## Mount Leven Roundabout, Stockton-on-Tees

Stage 3 Road Safety Audit

25<sup>th</sup> October 2017

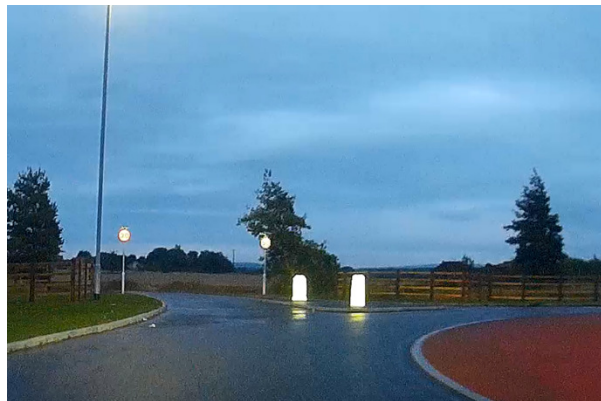
A street lighting column has been installed close to the roundabout eastbound entry in the northern verge. It would appear that this column is not a 'passive' column whereas all other new lighting columns appear to be. Should an errant vehicle collide with the column, the severity of injury to occupants will be increased. Whilst the Audit Team acknowledges that speeds should

be low at this point, this is countered by the fact that the column is located on the outer edge of the horizontal curvature, increasing the risk of an errant vehicle leaving the carriageway.

**RECOMMENDATION:** Replace the column with a passively safe column.
